Addendum #5 to SJPC-22-49 (BMT Rail Rehabilitation): September 1, 2022

Answers to Potential Bidders' Questions

DWG. NO.	1599
TITLE	M8 FLAT 8'-7" TIE IN CONCRETE ENCASEMENT UNINSULATED

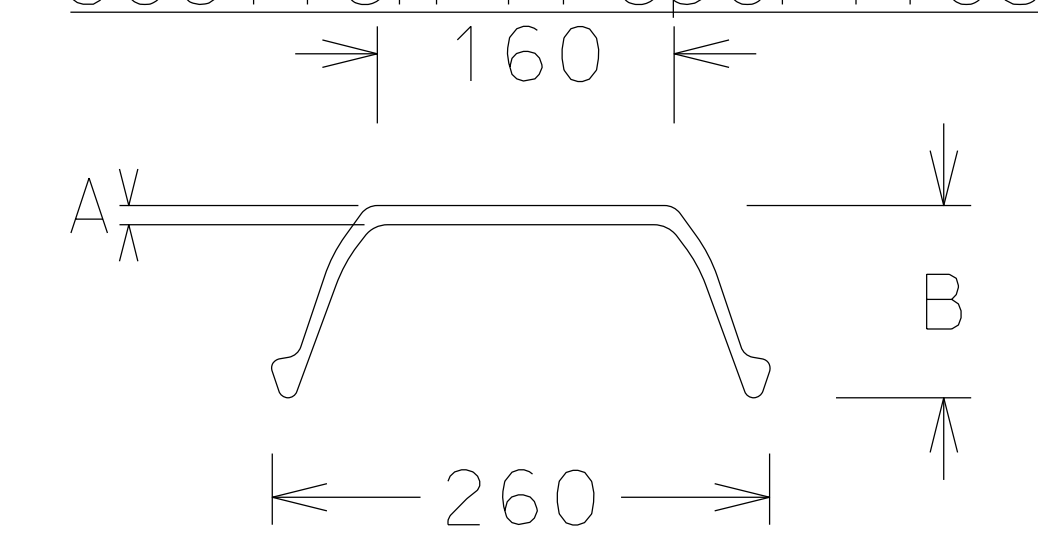
- Q1: Contract dwg T-26 note 6 specifies the use of a Narstco # 1599 steel cross tie. Please be advised this model number does not exist. Please specify the correct Narstco steel tie that can be used in embedded track.

- A1: Copy of NARSTCO drawing for Steel Crosstie #1599 attached.
- Q2: Addendum 4 - A7 specifies to use detail Detail 3/T-20 for turnouts that are embedded in concrete that are not on the berth. Is the intent of detail 3 SECTION USED ROLLED STEEL CROSS TIE to use a Nartsco steel tie? If so please confirm Narstco steel ties are compatible with a tounge and mate turnout.
